STAFF REPORT

Review of Anaheim Public Utilities 2023 Integrated Resource Plan

April 2025 | CEC-200-2025-009

Figure 2: APU's 2025 Portfolio Mix

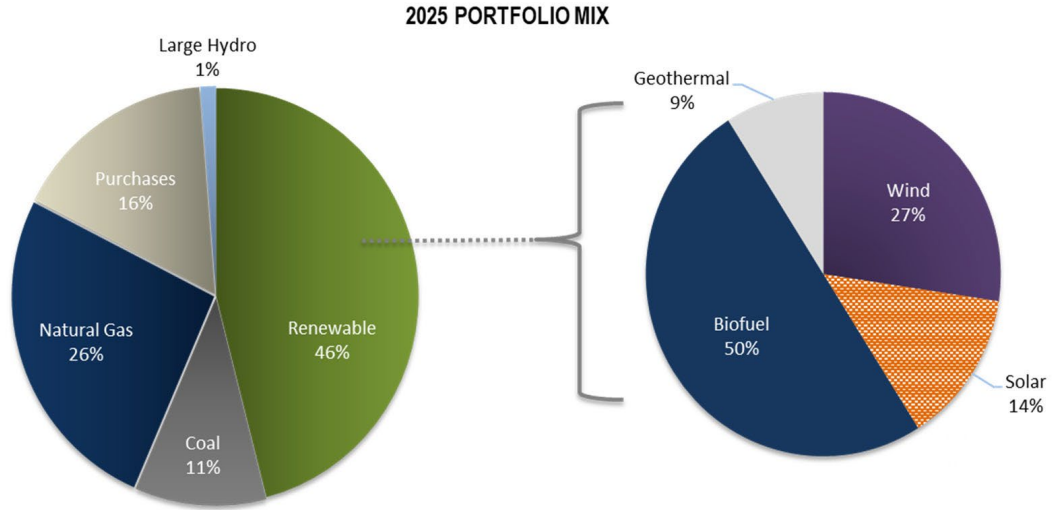
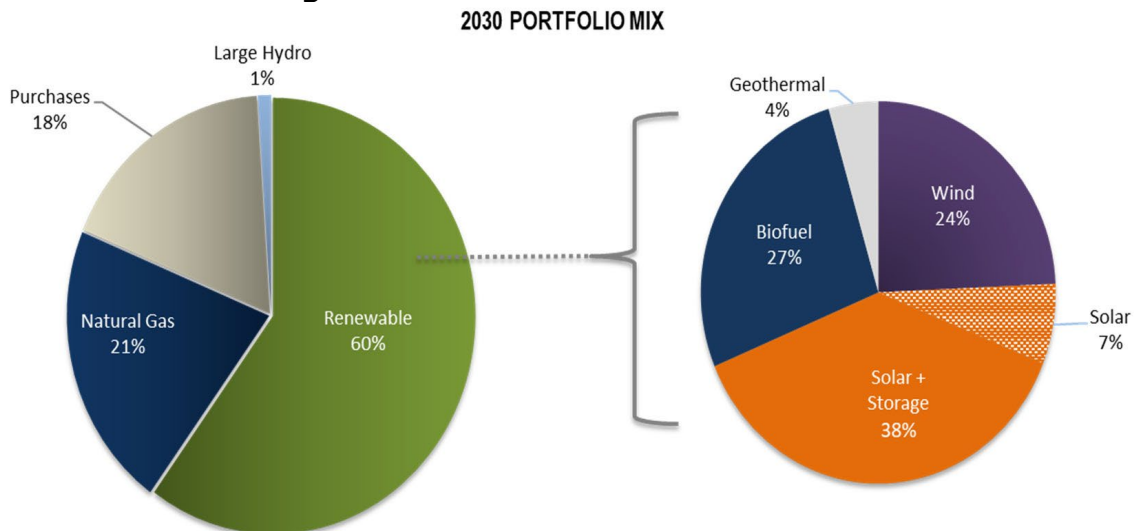
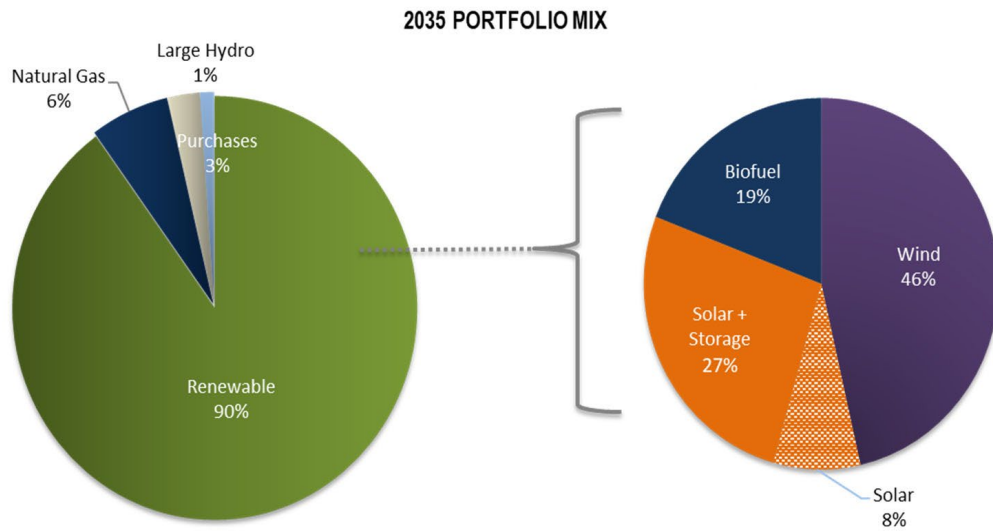
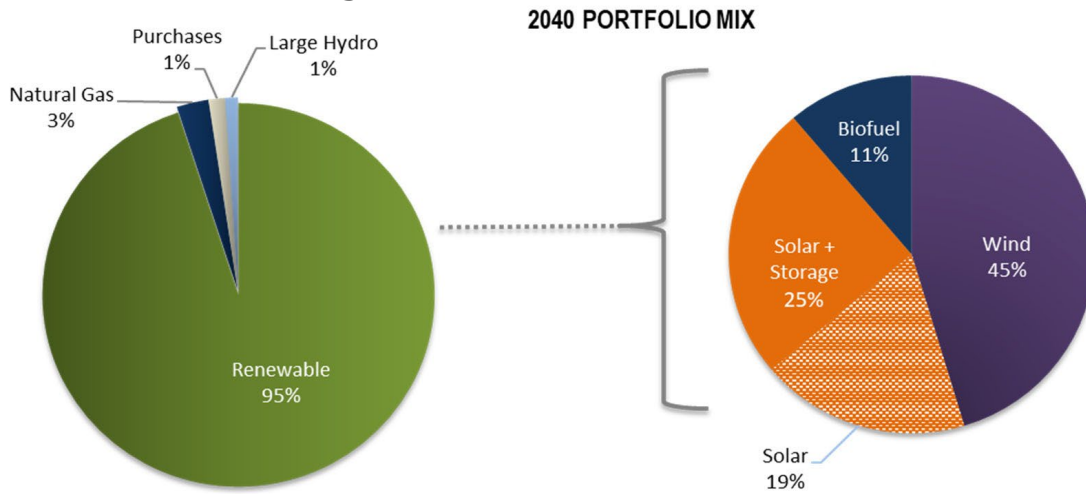
Under the Reliability Portfolio, APU plans to add cost-effective resources including utility-scale solar plus battery storage, solar, and wind, as existing contractual obligations end over time. Adding these resources will allow APU to gradually decrease fossil-fuel generation over time while maintaining grid reliability. The new resources recommended by the optimization model runs will meet RPS requirements and constraints, planning reserve margins, environmental goals, reliability, and costs. Figures 2-5 shown below are APU's planned portfolio mix in five-year increments.
